# **SAFETY EVALUATION OF THE INDIAN POINT NUCLEAR GENERATING UNIT NO. 3**

**Docket No. 50-286**

**Issue Date: September 21, 1973**

SAFETY EVALUATION REPORT  
BY THE  
DIRECTORATE OF LICENSING  
U.S. ATOMIC ENERGY COMMISSION  
IN THE MATTER OF  
CONSOLIDATED EDISON COMPANY OF NEW YORK, INC.  
INDIAN POINT NUCLEAR GENERATING UNIT NO. 3  
DOCKET NO. 50-286

FIGURE 10.1  
ELEVATION VIEW  
SHIELD WALL REGION

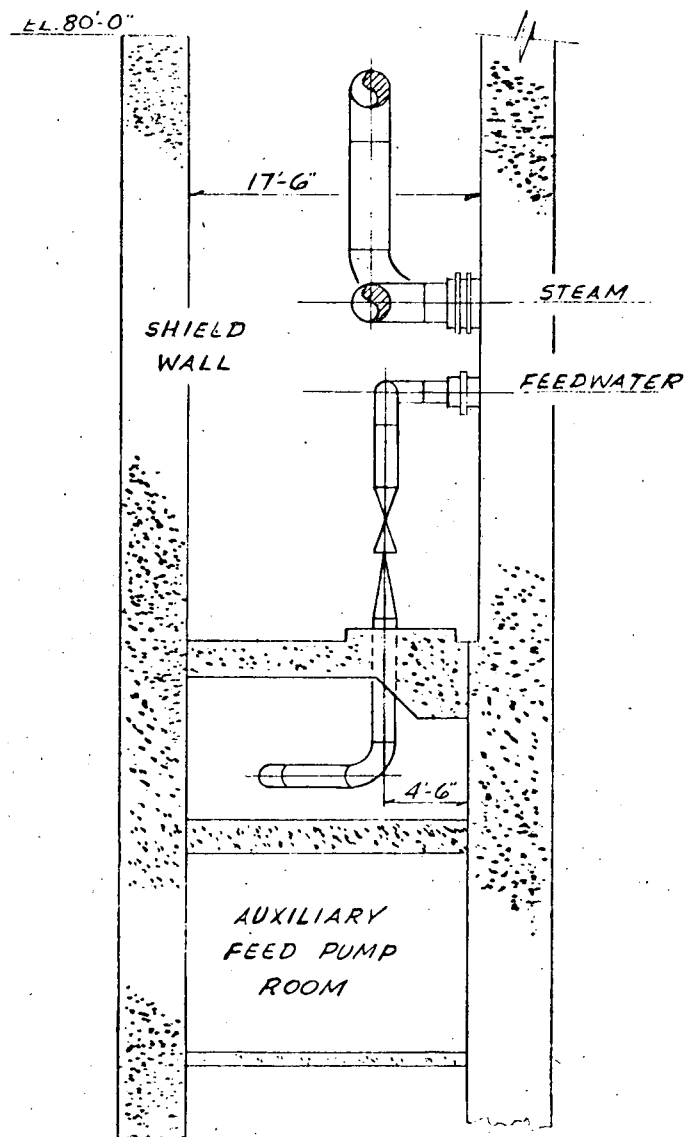
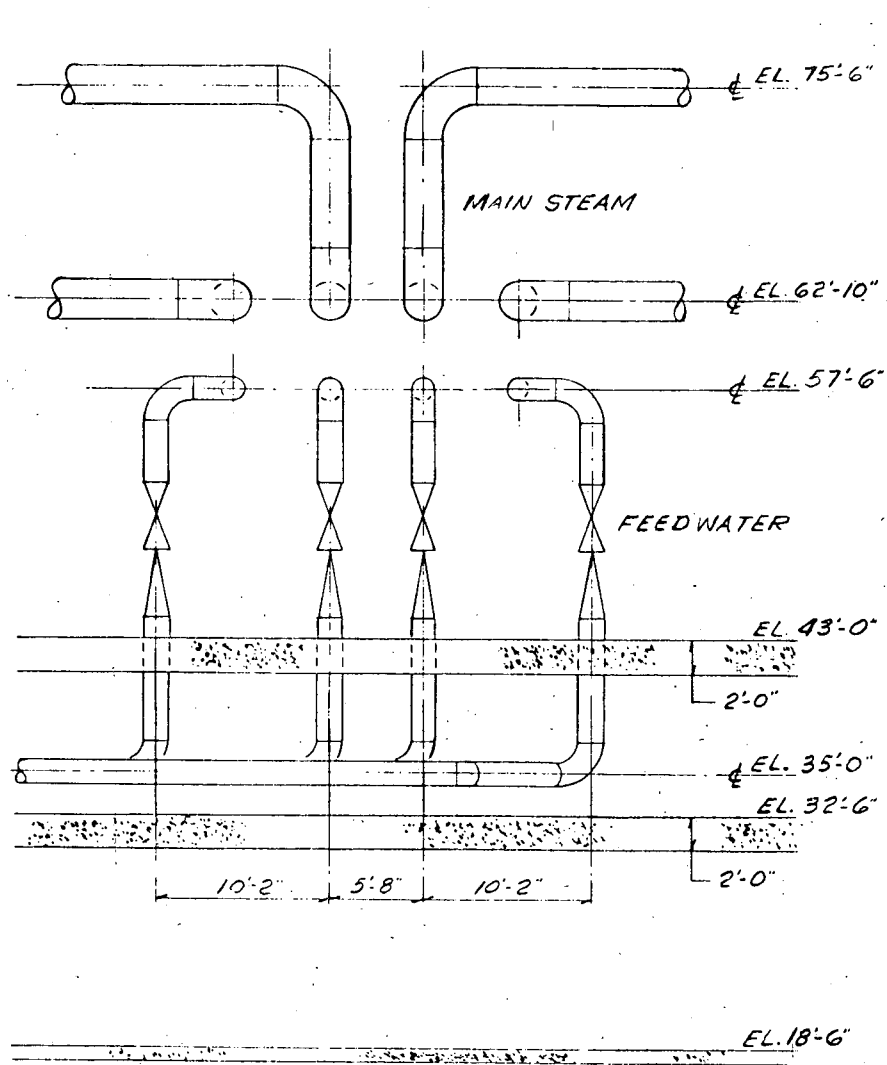
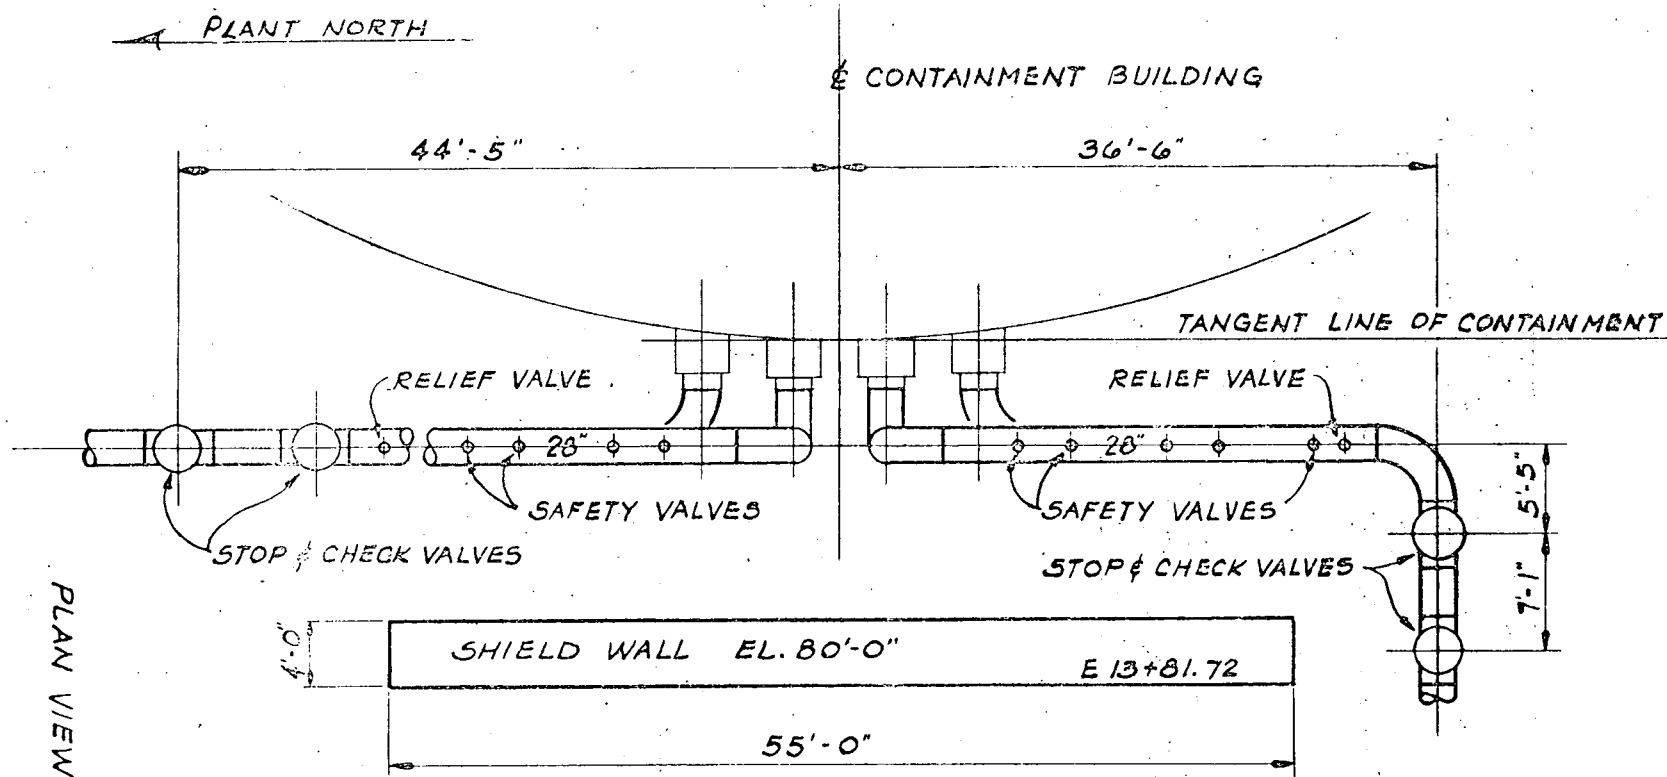
Design modifications that have been required as a result of the review of the smaller high energy lines include the addition of pipe restraints to portions of the steam generator blowdown lines, shielding around cable trays to eliminate jet impingement effects and an alarm system to prevent overheating of the penetration area because of a ruptured letdown line, steam generator blowdown line,

sample line, or auxiliary steam line. The staff has reviewed these design modifications and finds them acceptable.
